Addendum 02 for RFB935800-01

Project Name: Lucas ICN CRAC Replacement
DAS RFB #: 935800-01
DAS Project #: 9358.00
Date: 6/18/24

Contents:

GROUND FLOOR PLAN - HVAC - DEMO

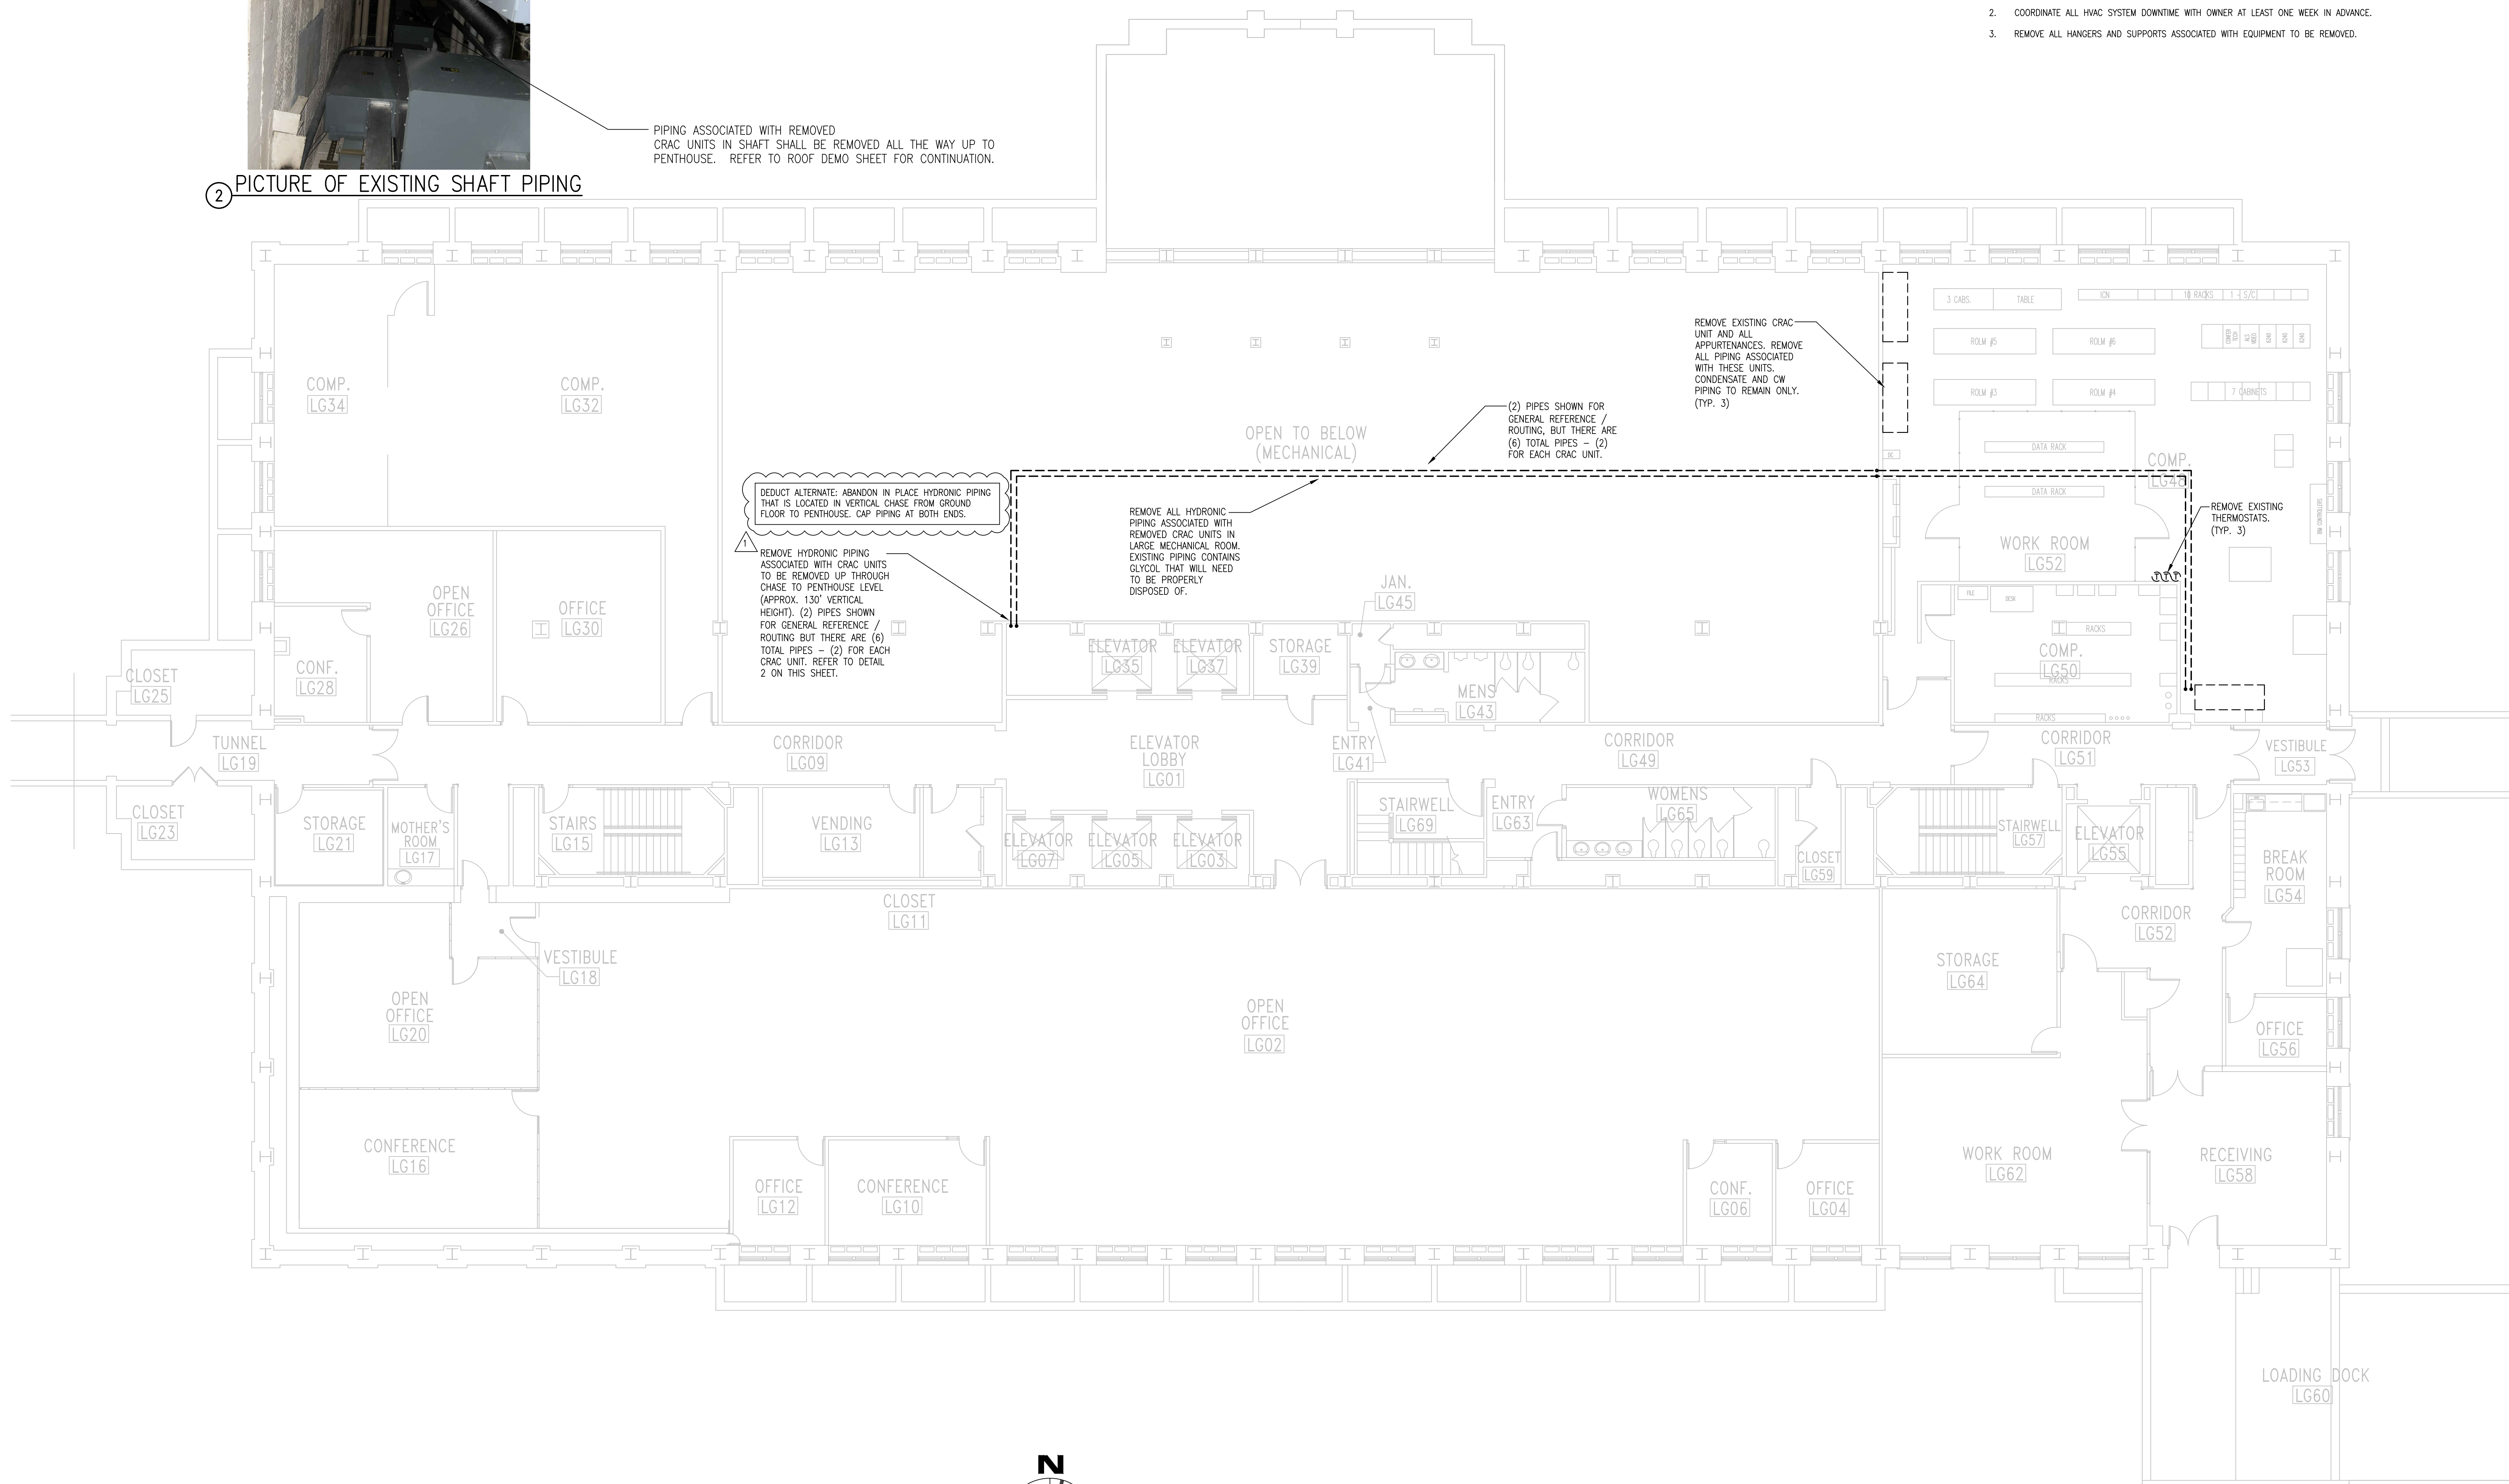
1. Drawing MD1 – Ground Floor Plan – HVAC - Demo:
 - a. ADD note about deduct alternate to abandon piping in vertical chase.
 - b. Refer to attached full size sheet MD1.
2. Drawing MD2 – Penthouse and Roof – HVAC - Demo:
 - a. ADD note about deduct alternate to abandon piping in vertical chase.
 - b. Refer to attached full size sheet MD2.
3. Drawing M2 – Mechanical Details and Schedules:
 - a. ADD note about owner provided /contractor installed equipment.
 - b. ADD note to Computer Room AC unit and CRAC Unit Condensing Unit schedules about owner provided/contractor installed equipment.
 - c. Refer to attached full size sheet M2.

PIPING ASSOCIATED WITH REMOVED CRAC UNITS IN SHAFT SHALL BE REMOVED ALL THE WAY UP TO PENTHOUSE. REFER TO ROOF DEMO SHEET FOR CONTINUATION.

FIRST FLOOR PLAN - ELECTRICAL

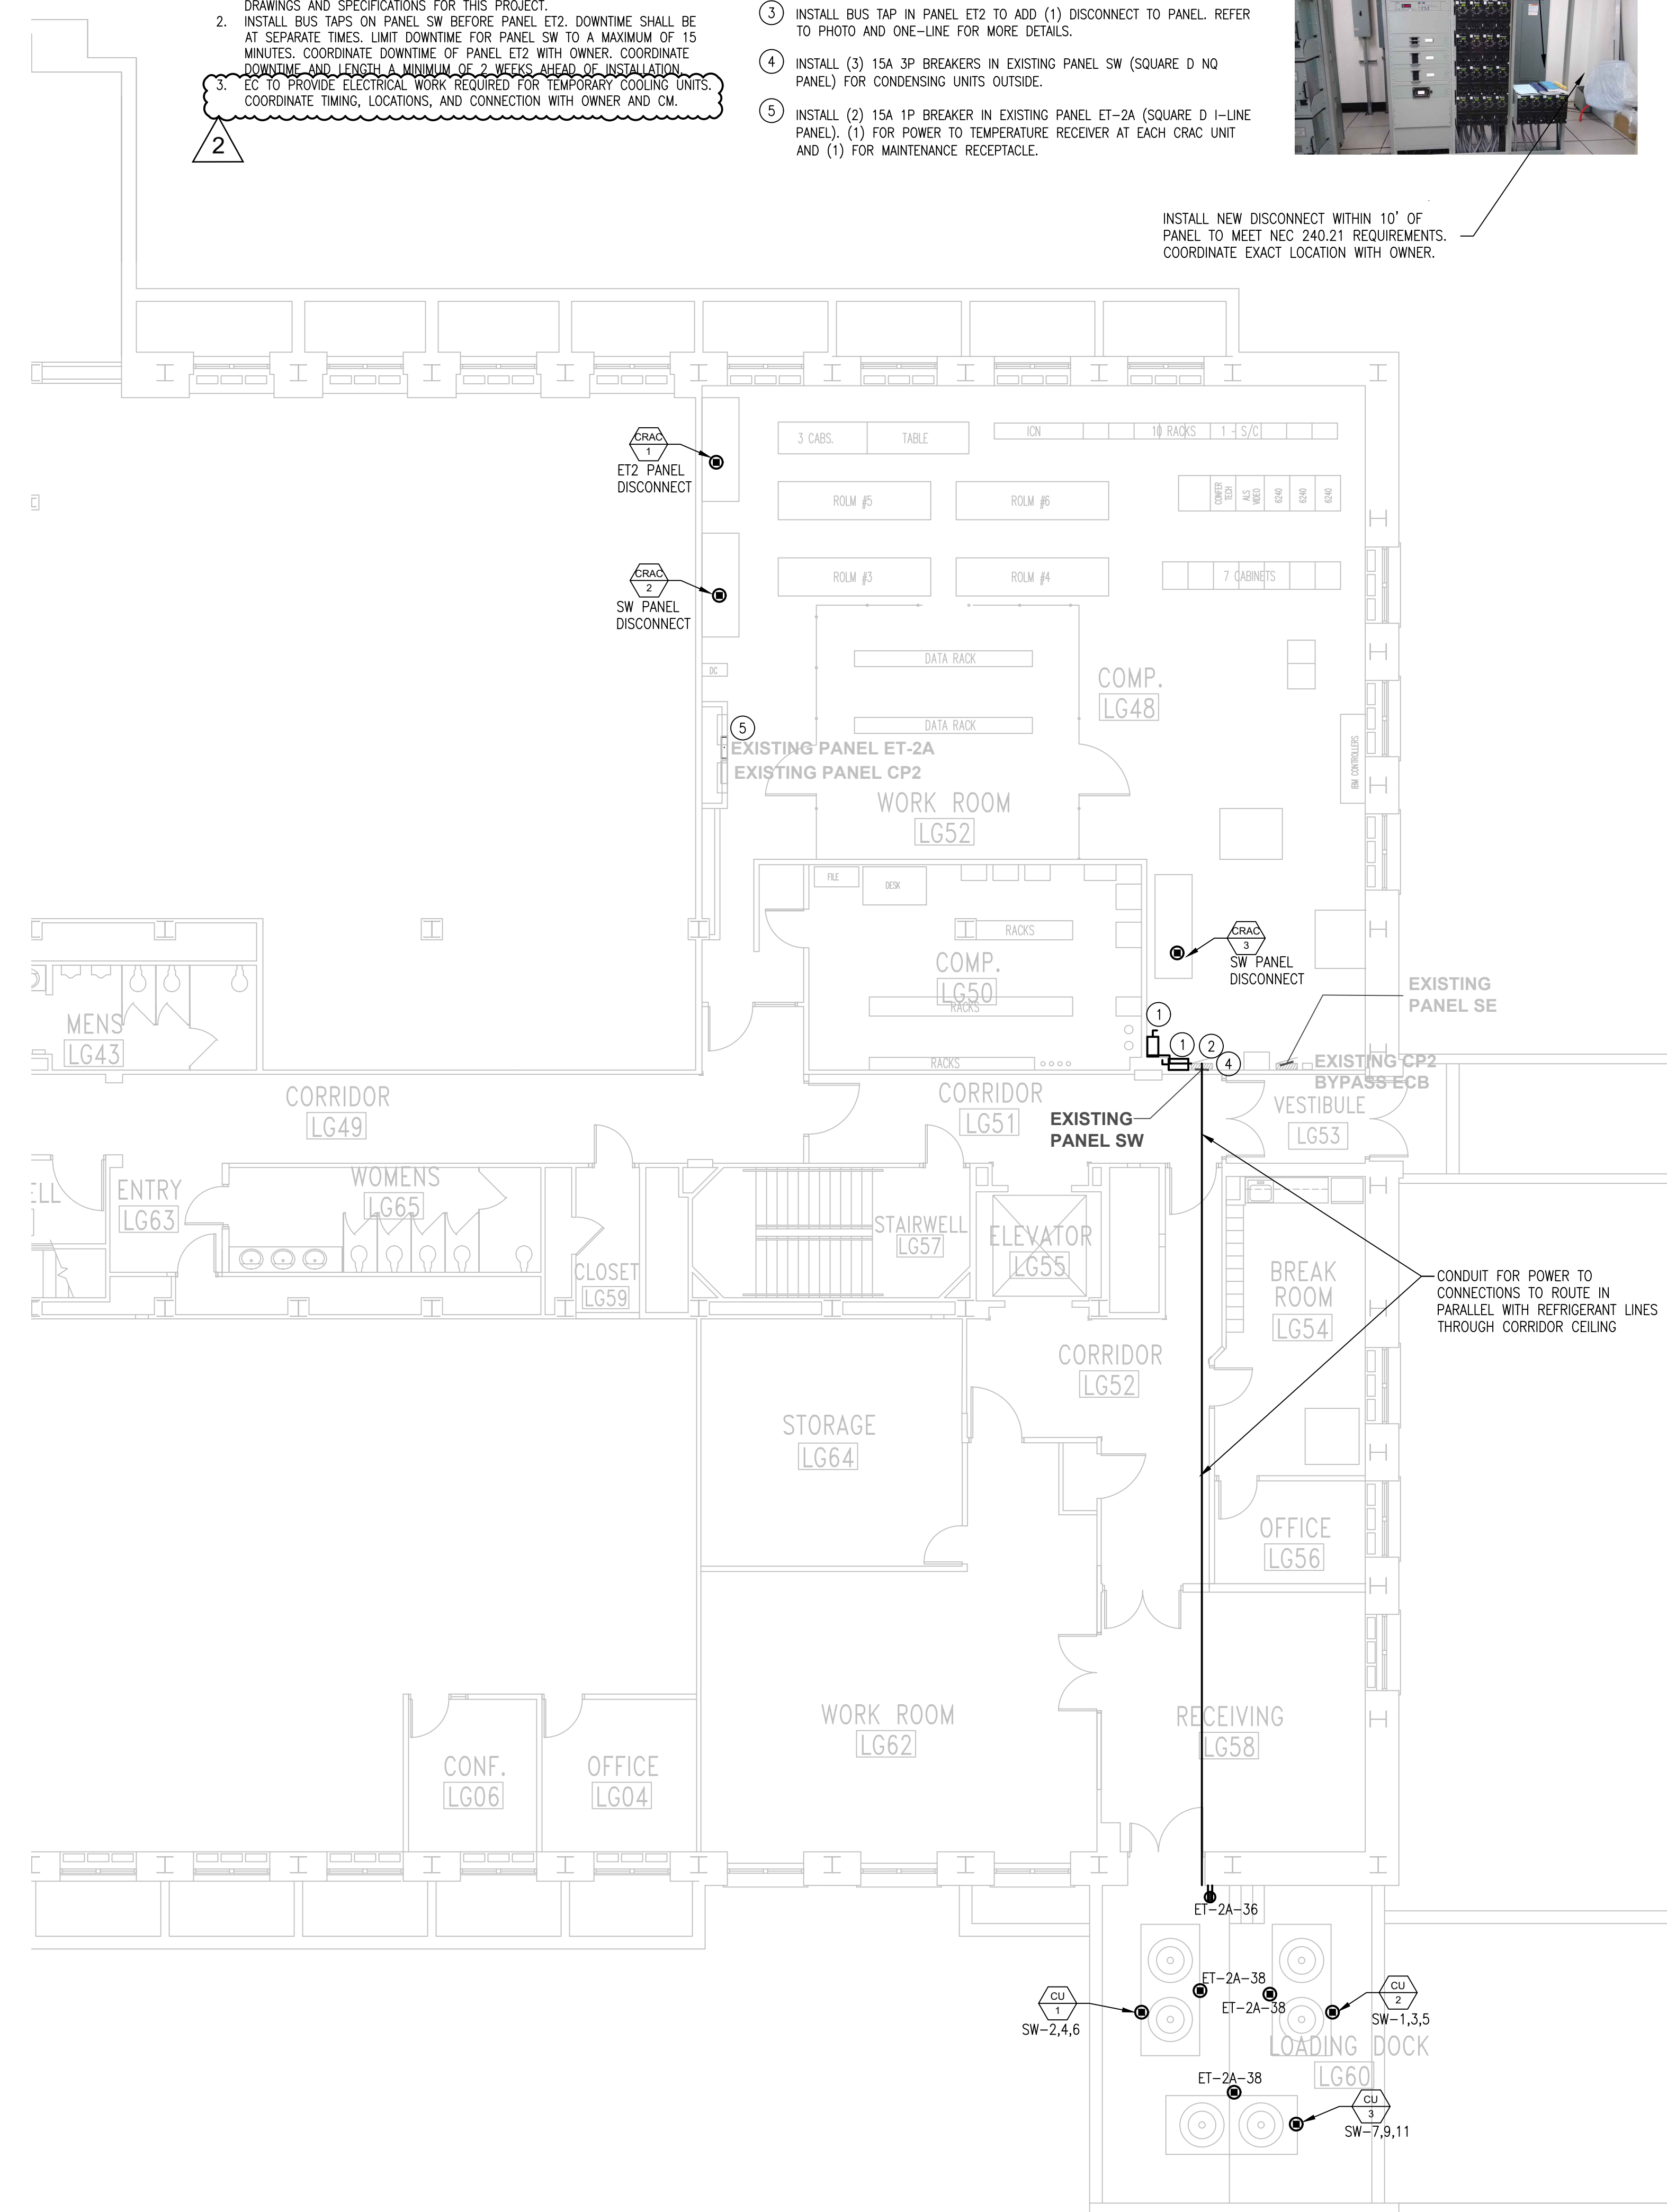
2. Drawing E1 – Electrical Plan
 - a. ADD note for electrical contractor to provide power for temporary AC units.
 - b. Refer to attached full size sheet E1.

- IC TO PROVIDE ELECTRICAL WORK REQUIRED FOR TEMPORARY COOLING UNITS. COORDINATE TIMING, LOCATIONS, AND CONNECTION WITH OWNER AND CM.
